## **Attachment 7** Staff and REBIC Correspondence on Attachment 6 Amendment Alternative

**Subject:** RE: Huntersville Ordinance Amendment

### Driveways on 50+ Wide Lots

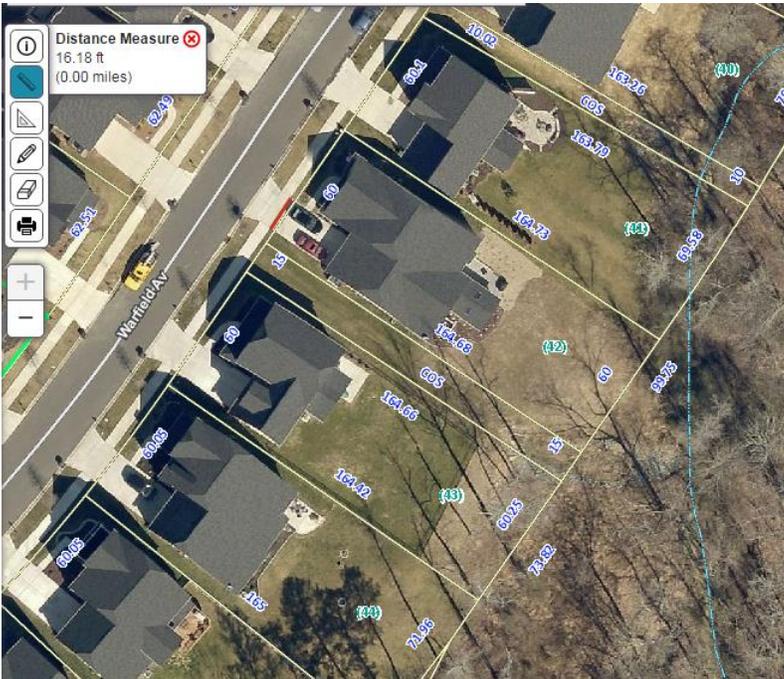
In the example below under the current standards, lots 60' wide or less would not have driveways on the public street but instead would be served by an alley. Under the compromise, there could be nine 12' wide driveways each side of the block representing about 23% of the block length dedicated to driveways (not including the driveway flare).

- 480' long block with 9 homes per side (53' average lot width)
- Today: No driveway cuts (0% of block length)
- Possible: 12' wide driveway at r/w (12' wide x 9 lots = 108' of driveway or 23% of block length)

Your illustration shows exactly why my members are so concerned about a 12' maximum driveway width at ROW. It either creates a challenging driveway pad or forces the house to be setback a minimum of 30', which goes against the pedestrian-friendly streetscape Huntersville is trying to create. I think we can live with a maximum width of 15' or 14' *at curb*, but anything less creates unintended consequences for neighborhood development.

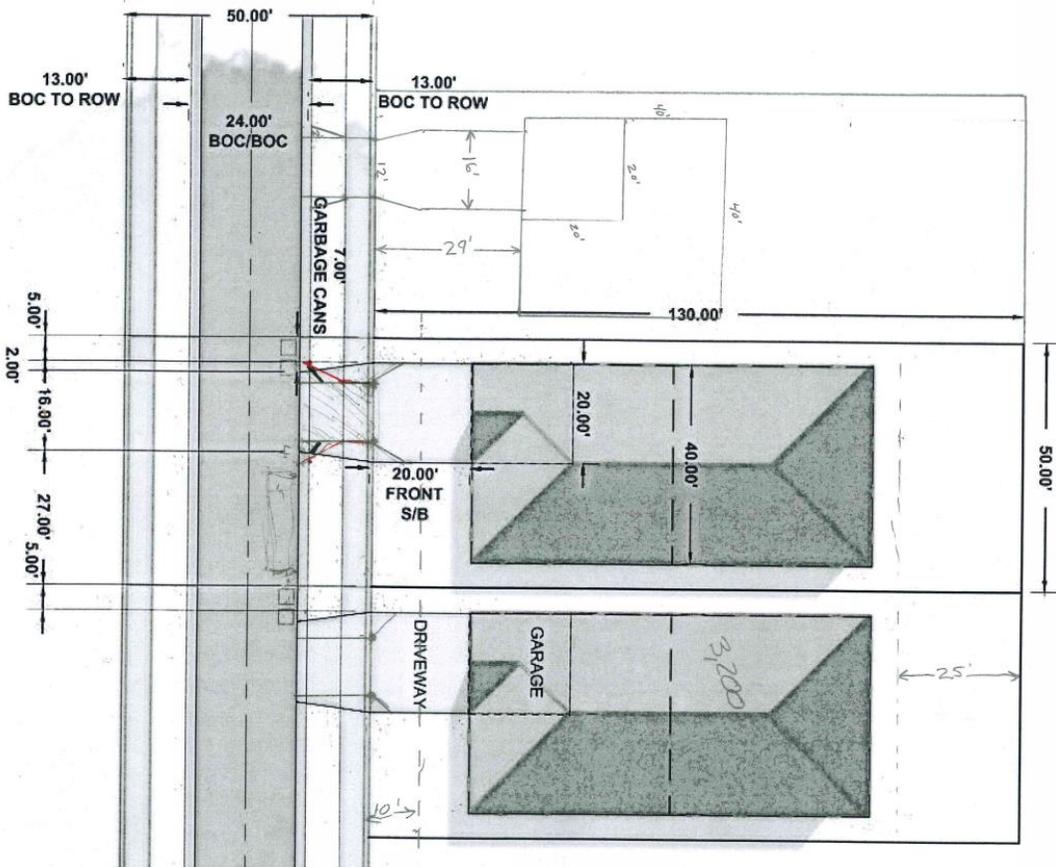
Thank you for the time you and Bob Wiggins took to meet with David Peete and I. Unfortunately I was unable to set-up the management team meeting today but hope to Monday. I spent some time looking at the realities of what is built in the field and found that houses on 50'+ -wide lots were around 40' (see attached). Certainly every home is different and they can be shorter or deeper, but I wanted to get at least some idea about what might get built on 50'+-wide lots. I also found that driveways were often the width of the garage door or slightly wider (16'-17' +/-) and the "flare-out" between the street and sidewalk was often about 2' each side (see photos below). I put that information into the attached site plan to see what that might look like with the 12'-wide drive we said we could accept with REBIC's buy-in. As an FYI, Huntersville has 3 roll-out carts (household, yard (weekly) and recycle (bi-weekly)).
